**MAJOR PROJECT ASSESSMENT:  
7-9 Gibbons Street, Redfern  
(MP08\_0112 MOD3)**

Director-General's  
Environmental Assessment Report  
Section 75W of the  
*Environmental Planning and Assessment Act 1979*

November 2012

**Figure 2 – Proposed External Works (highlighted in yellow)**

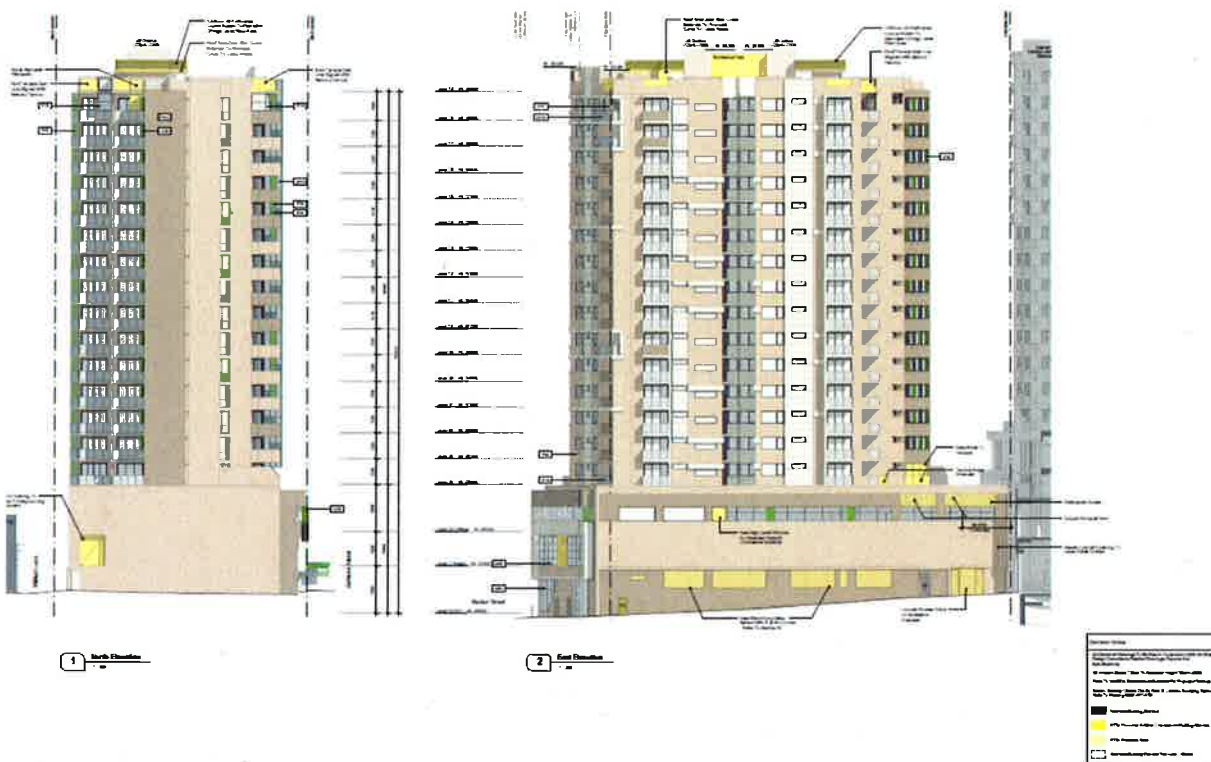
The extent of external works is shown in Figure 2 below.
